Anacortes City Council
Municipal Building Council Chambers
904 6th Street

May 21, 2018
6:00 p.m.

*** REVISED * PRELIMINARY AGENDA**

SHEET:
D19
D19
SCALE:
N.T.S.

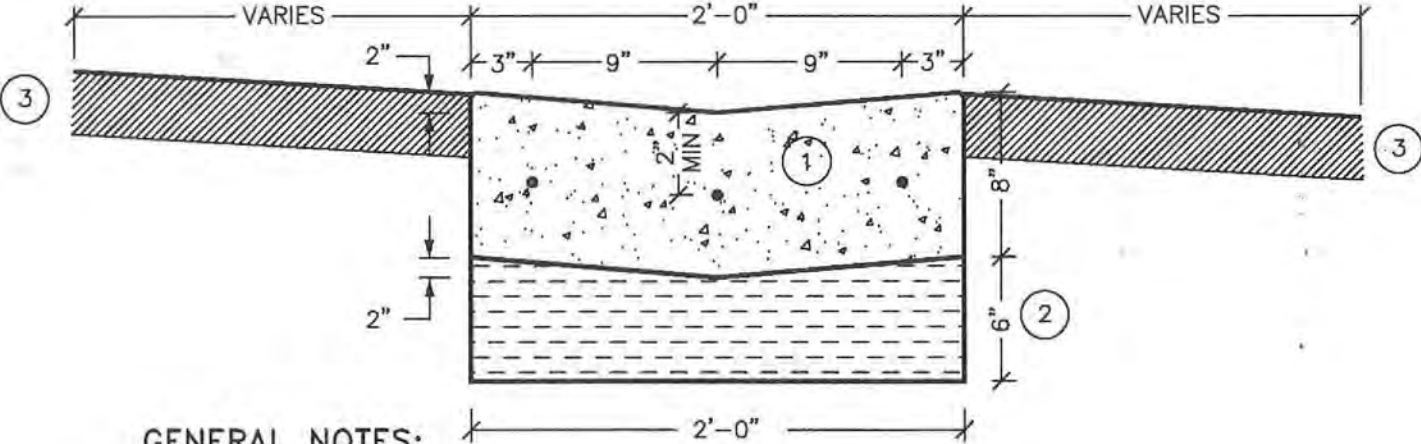
- Reason for Contract Change:** During review of the required pavement repair areas during the design phase of the 2018 Asphalt Overlay project (PW-001-TRN-003) it was discovered that significant repairs to the existing asphalt were required along the paving valley between the parking pocket and the driving lane adjacent to Whitney School. This area is along M Avenue between 12th and 14th Streets. See attached Plan sheet. A more permanent solution to the pavement failure in this area would be to install a concrete v-gutter between the parking pocket and the drive lane.

As the 2018 Asphalt Overlay project included no similar concrete work and as the 2018 Asphalt Overlay Utility and Pedestrian Improvements Project (PW18-001-TRN-001) was under construction in the same area and included significant concrete work, Trinity Contractors, the contractor for the 2018 Asphalt Overlay Utility and Pedestrian Improvements Project, was asked to provide a change order proposal for the v-gutter. The change order proposal was based upon the revised Plan sheet C13 and the new detail sheet D19.

"The work as described above is hereby amended per Modification 01. The Contractor will install a concrete v-gutter between the parking pocket and the drive lane along M Avenue between 12th and 14th Streets per revised Plan sheet C13 and the new detail sheet D19, which are hereby incorporated by reference and made a part hereof."

- 22 REMOVE EXISTING THICKNESS OF ASPHALT (ASSUME 2-INCHES).
- INSTALL CRUSHED SURFACING TOP COURSE TO REGRADE FOR RAISED CROSS WALK PER PLAN AND PROFILE ON SHEET D14.
 - PLACE 3" HMA CL. 1/2 INCH PG64-22 TO FINISHED GRADE.
- 23 EXCAVATE EXISTING MATERIAL PER SIDEWALK CROSS SECTION DETAIL ON SHEET D1 FOR NEW SIDEWALK AT BUS STOP.
- INSTALL CEMENT CONCRETE SIDEWALK PER WSDOT STD. PLAN F-30.10-03, SIDEWALK CROSS SECTION DETAIL 2 ON SHEET D1.
- 25 EXCAVATE EXISTING MATERIAL PER V-GUTTER CROSS SECTION DETAIL 1 ON SHEET D19 FOR NEW V-GUTTER.
- INSTALL 159 LF OF V-GUTTER PER CROSS SECTION DETAIL 1 ON SHEET D19.

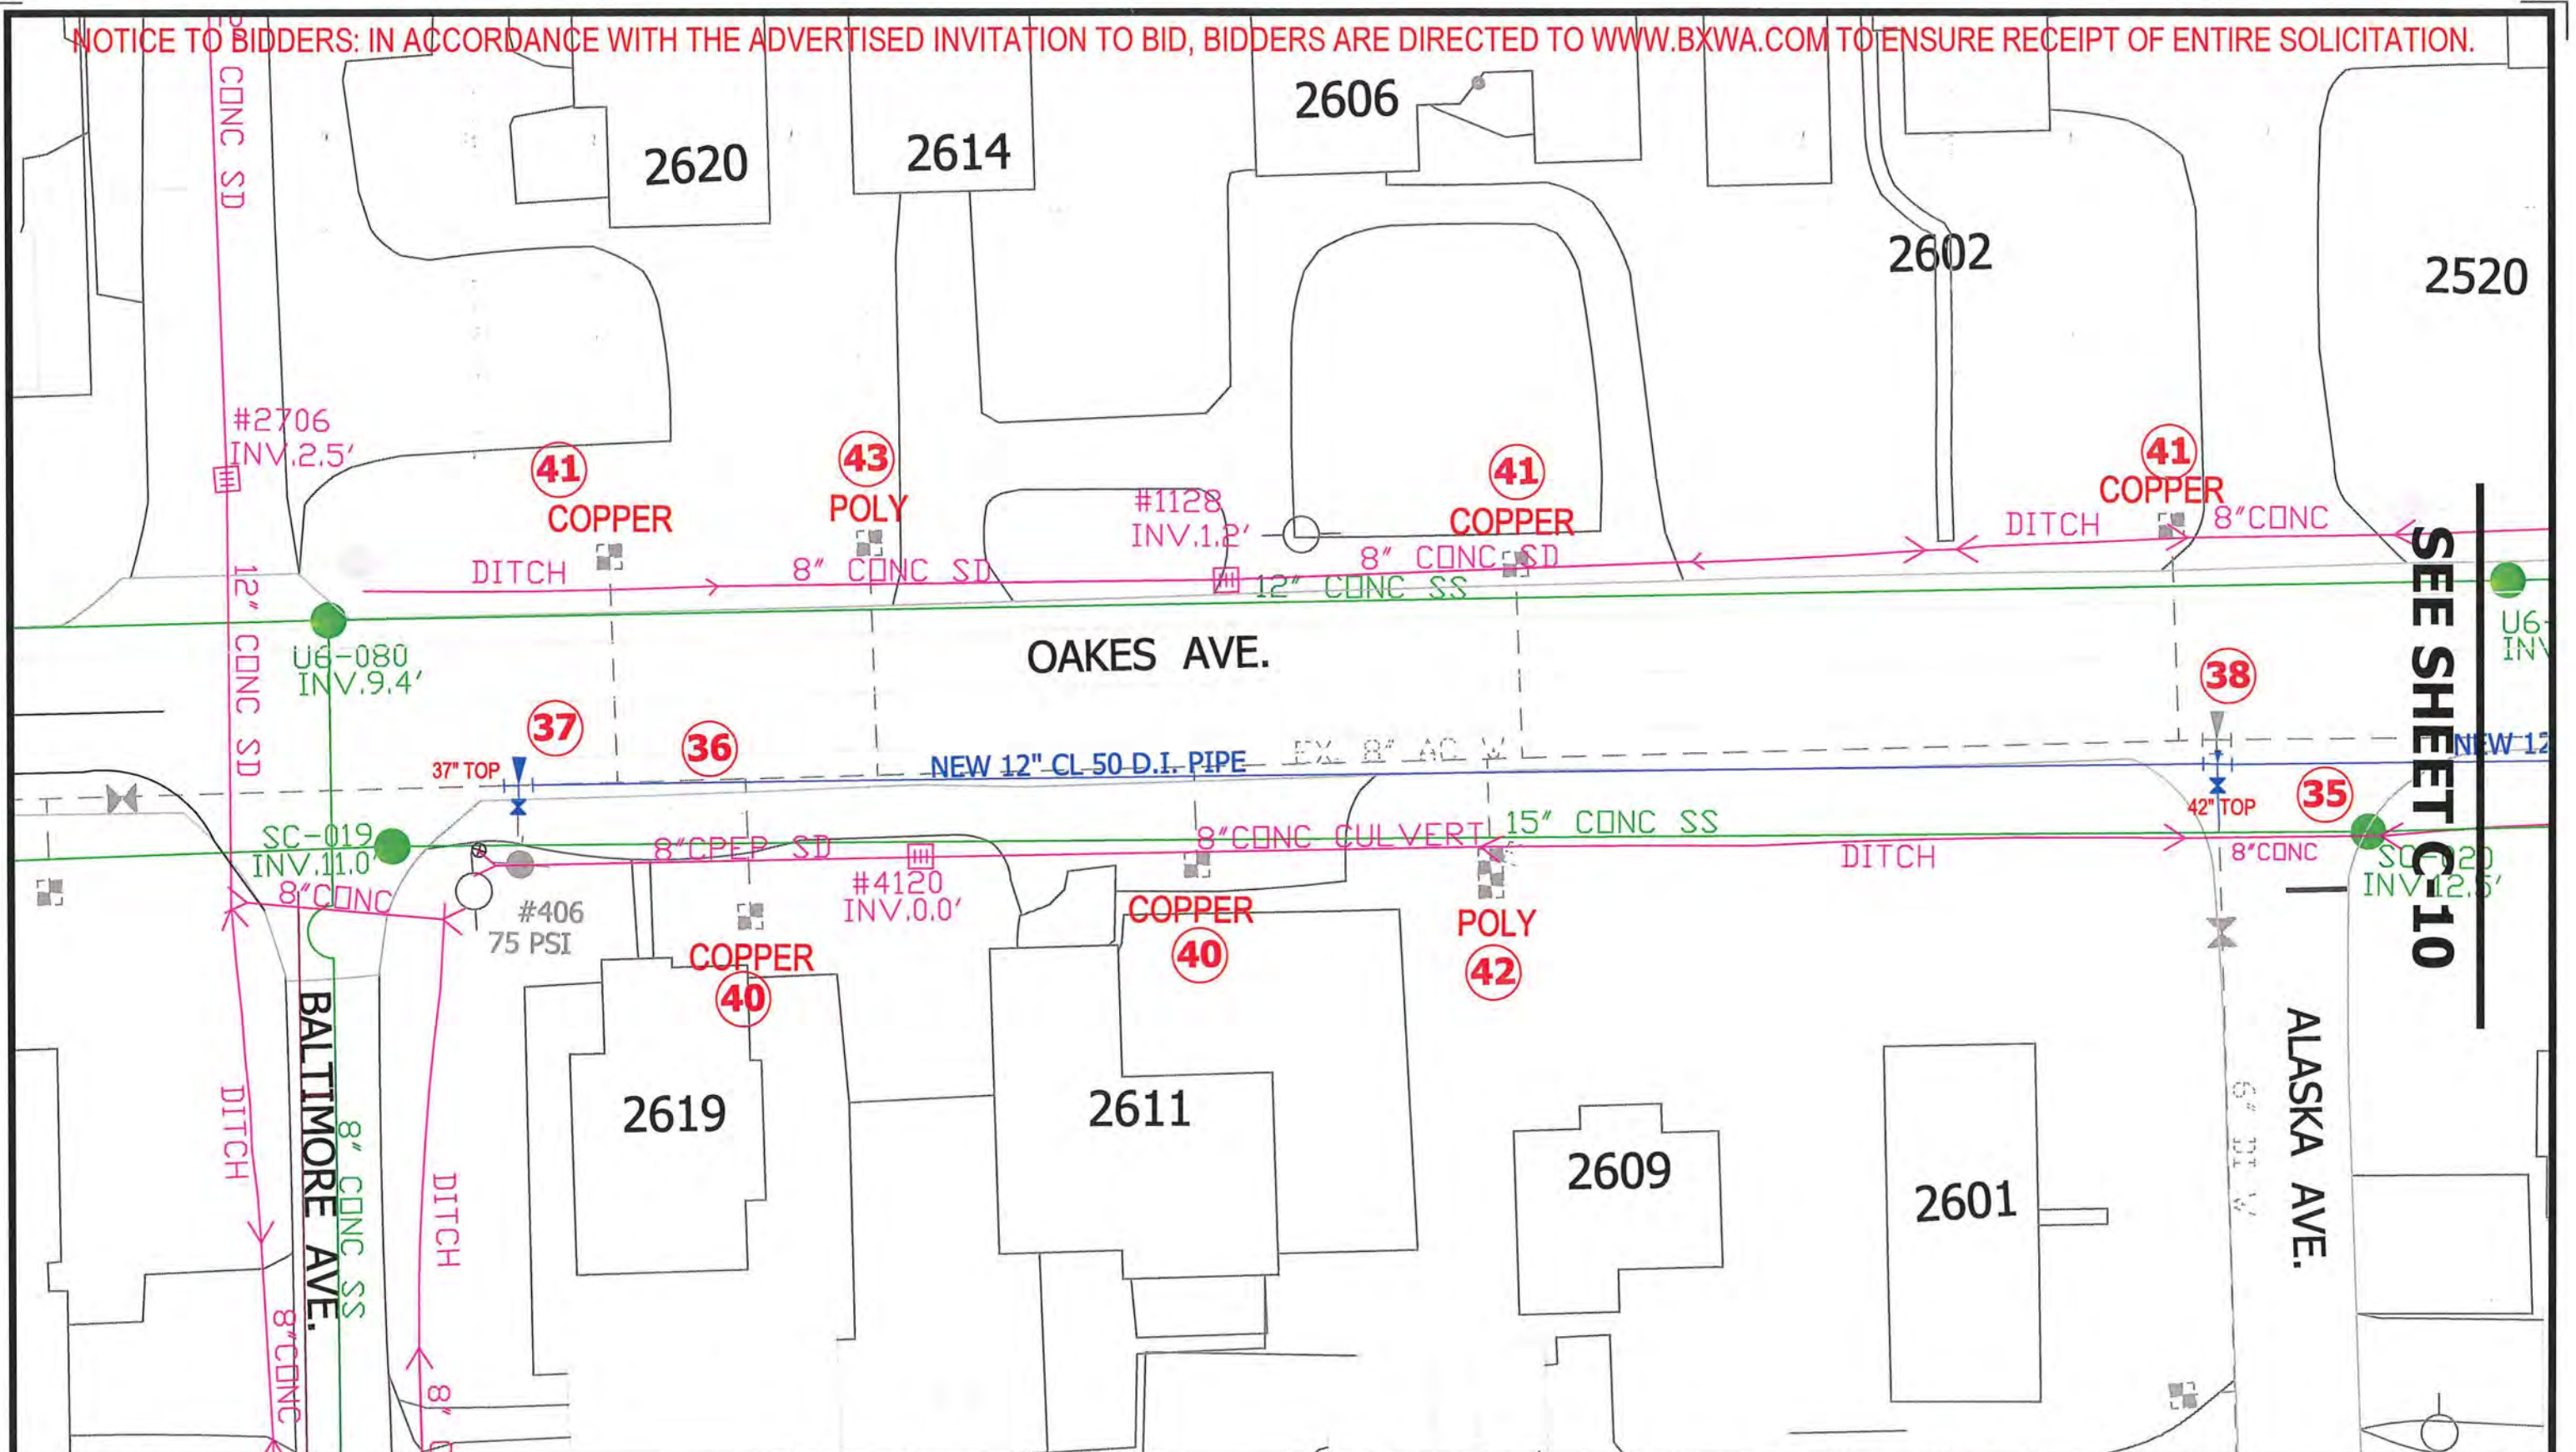
1. **Reason for Contract Change:** An existing aging waterline located on Oakes Avenue near Baltimore Avenue has failed twice over a four month period; the last break occurred on March 24th of this year. Both breaks resulted in significant property damage. When the waterline was exposed for repair, it became evident that additional failure events are likely if this pipe section is not repaired soon. Because of the imminent threat to public health and safety, the City would like to direct C. Johnson Construction to replace this pipe while they are already mobilized in the area as part of the 2018 Waterline Replacement Project. Therefore, this change provides the labor and equipment necessary to install a new waterline using City supplied materials in order to replace the existing vulnerable portion of the waterline on Oakes Avenue between Baltimore Avenue and A Avenue. In addition, due to ground water infiltration, 250 LF of interceptor drainpipe was required in the new waterline trench on Piper Circle to collect the ground water and redirect it to a nearby catch basin. The fiber conduit installation was required for the City's telemetry system.

"The work as described above is hereby amended per Modification 01. The Contractor will the install approximately 650 LF of owner provided 12" ductile iron water main, make tie-ins to the existing water system, materials to restrain any bends with non-restrained fittings, reconnecting to existing fire hydrants, renew/reconnect existing water services, and other work, Oakes Avenue, as detailed in Engineering Drawings C9, C10, and WN02. The City will furnish the necessary water pipe, gaskets, tees, valves, valve boxes, restraint fittings, all parts and pipe materials associated with renewing and reconnecting water services, 8-mil poly bagging, and any other necessary parts required for the installation of the 12" ductile iron water main. The Contractor will install 250 LF of interceptor drain on Piper Circle, including 100 SF of asphalt demo and pothole existing utilities. The Contractor will install 2,753 LF of City provided fiber optic conduit inside the water main."
